DUKE POWER COMPANY

Re: Catawba Nuclear Station  
Docket Nos. 50-413 and 50-414

On October 13, 1982, representatives from Duke Power Company and the NRC/  
Power Systems Branch met to discuss open items as documented in my letter  
of November 2, 1982. During this meeting the Staff asked a question con-  
cerning diesel generator operation during adverse environmental conditions.  
Duke's response is attached.

FIGURE 6 EXPERIMENTAL AND COMPUTER PREDICTED PERFORMANCE (Enterprise Test No. 144)

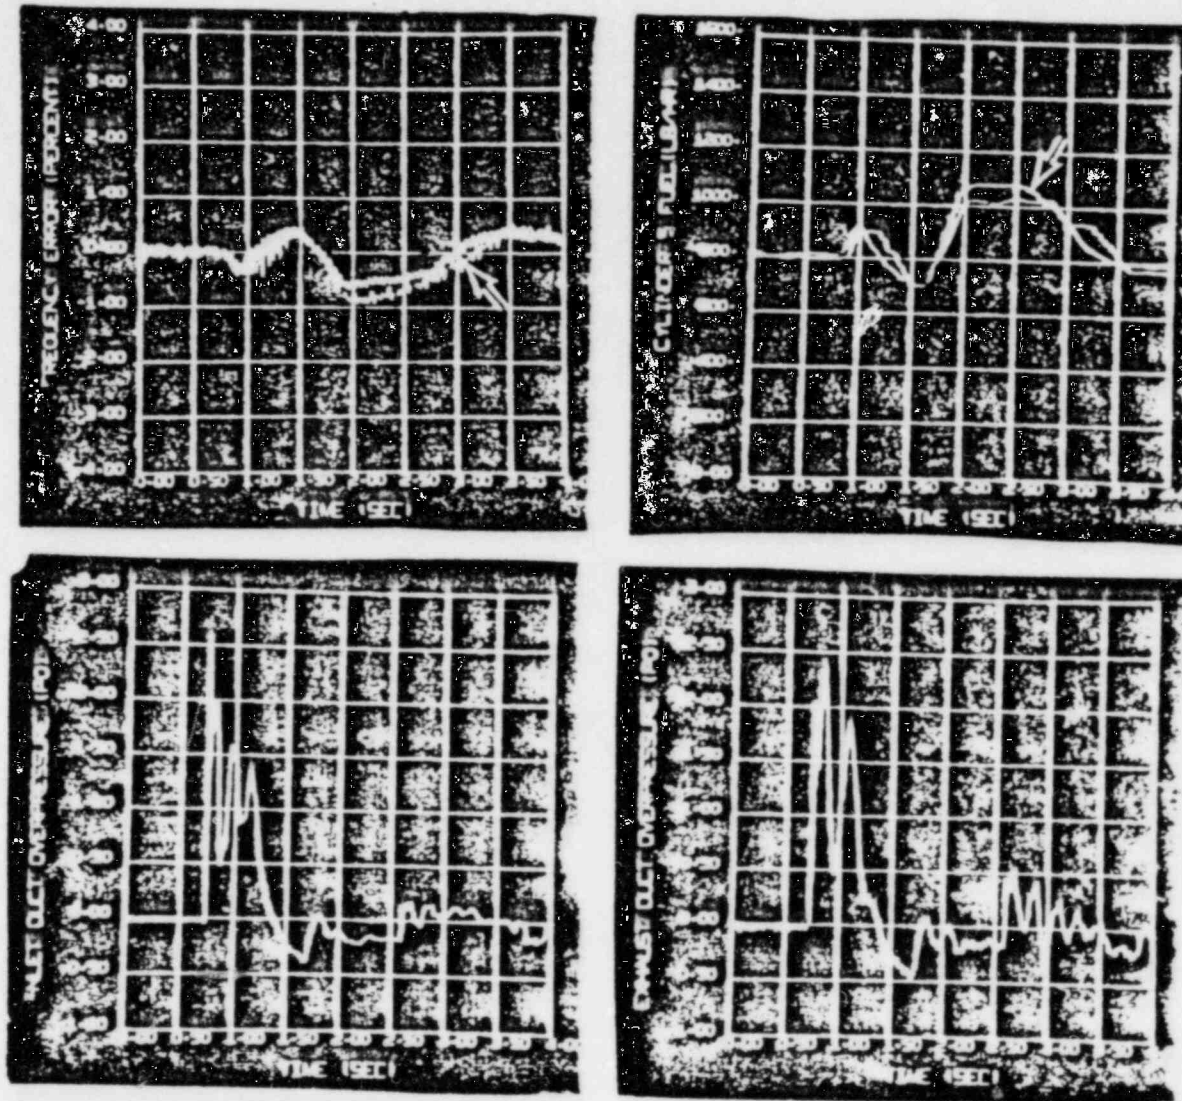
2. Provide a statement that indicates the ability of the diesels to operate during a sustained low pressure transient (26 inches of mercury for 12 hours) and also a sudden low pressure transient (a change of 3.0 psi in 1.5 seconds), but not simultaneously.

Enclosed is Table IV, "Dynamic Performance of Enterprise Diesel Engine - Electric Generator Set", and Figure 6, "Experimental and Computer Predicted Performance", which experementially predicts the effects of an under and over pressure on a typical Transamerica Delaval diesel engine and generator set. The test outcome showed no adverse effects of the over or under pressure; therefore we foresee no problem to the diesel engine generator set we will be furnishing you, should a pressure differential of -3 PSI in 1-1/2 seconds occur, i.e., a tornado. We sincerely hope that the included information is what you requested; however, should you need additional information, please feel free to contact me.
